City of Portland, Maine – Building or Use Permit Application 389 Congress Street, 04101, Tel: (207) 874-8703, FAX: 874-8716

| Proposed Project Description: 1st renovations to 1st floor unit - kitchen | | FIRE DEPT. <input type="checkbox"/> Approved <input type="checkbox"/> Denied Signature: <i>[Signature]</i> | | INSPECTION: Use Group: Type: | | Zone: CBL: 123-J-002 | |

| <p>Sam Martin Preliminary Kitchen Design 33 Fairmount Street Portland, Maine March 1998 Buell Heminway and Associates ARCHITECTURE • PLANNING</p> | | <p>Drawing Number: A-1 Title: PLAN Date: 3/20/98 Scale: 1/2"=1'-0" Drawn By: Buell Project Number: 9800</p> |

PLAN

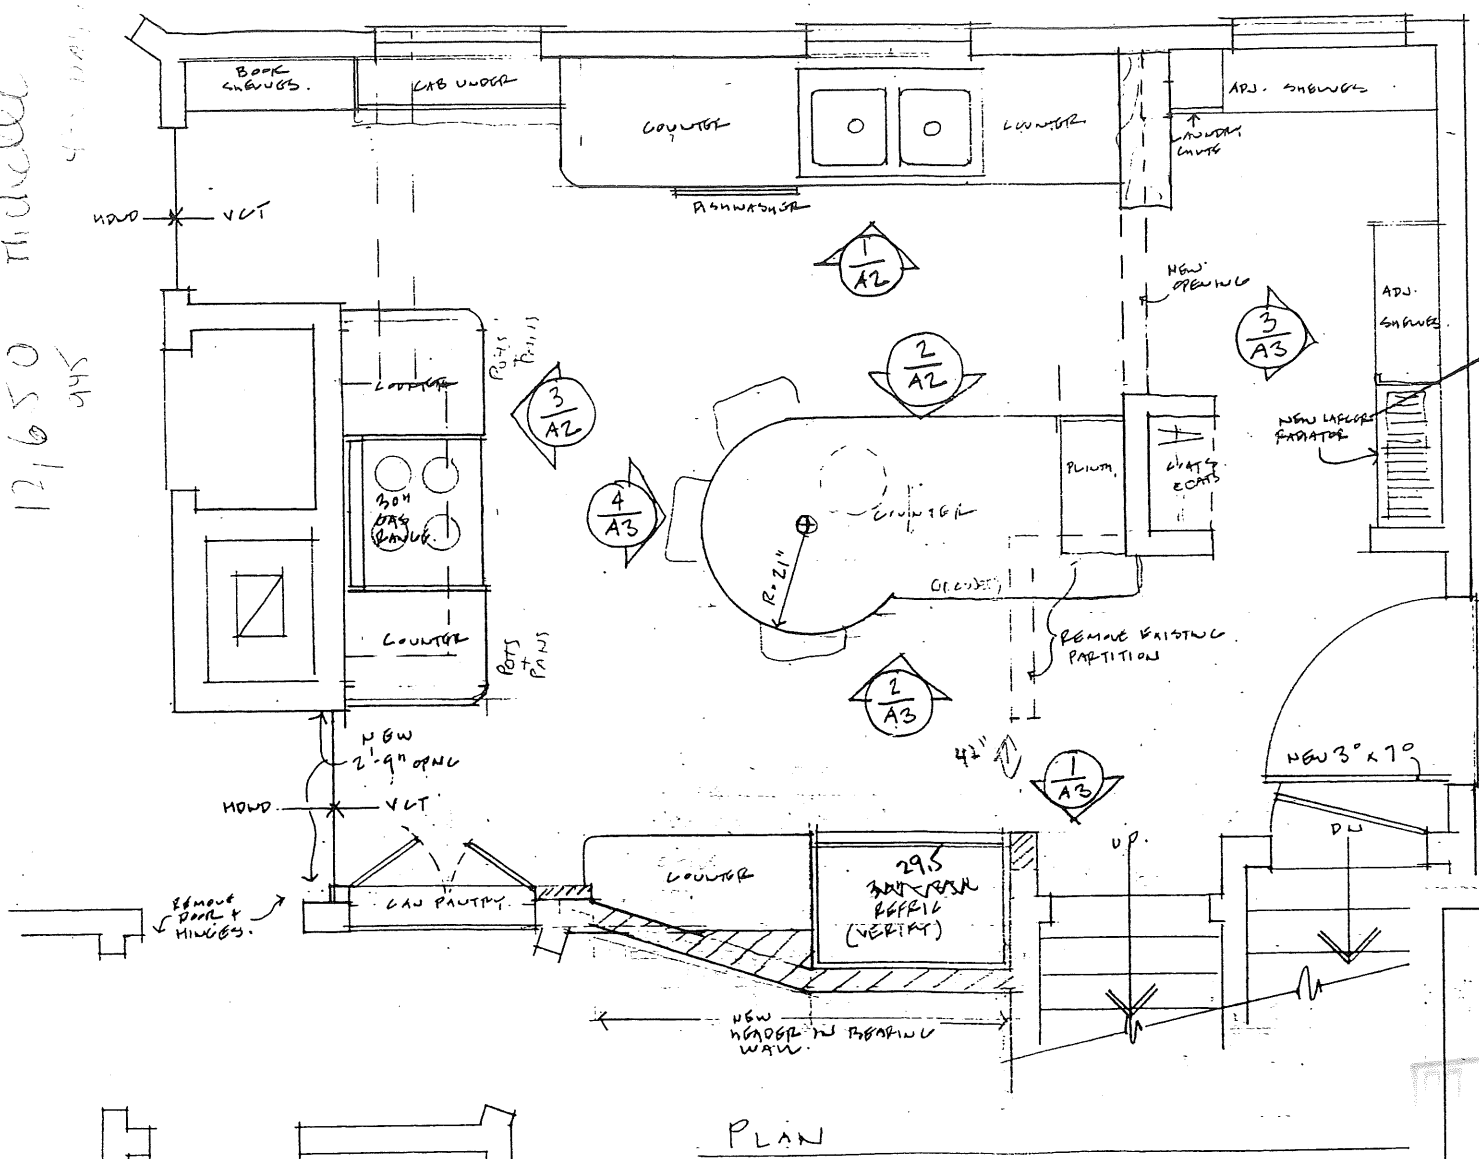
REDUCE ISLE
NEAR SINK
INCREASE ISLE
BY STAIRS

ISLES generally
42-54"
Buell shows 42"
between island and
between island and
between island and

- 1) OVERHEAD CABINET ABOVE COUNTER - ?
- 2) WALL CABINETS ABOVE DISHWASHER - ?
GLASS DOORS

ORDER POOR
LUTBER
CUT DOWN OPENING FACT
42" TO 56"
REDUCE COUNTER WIDTH - 5" ST
36" TO 30"
DEPTH OF REFRIG = 52"
WITH HANDLE
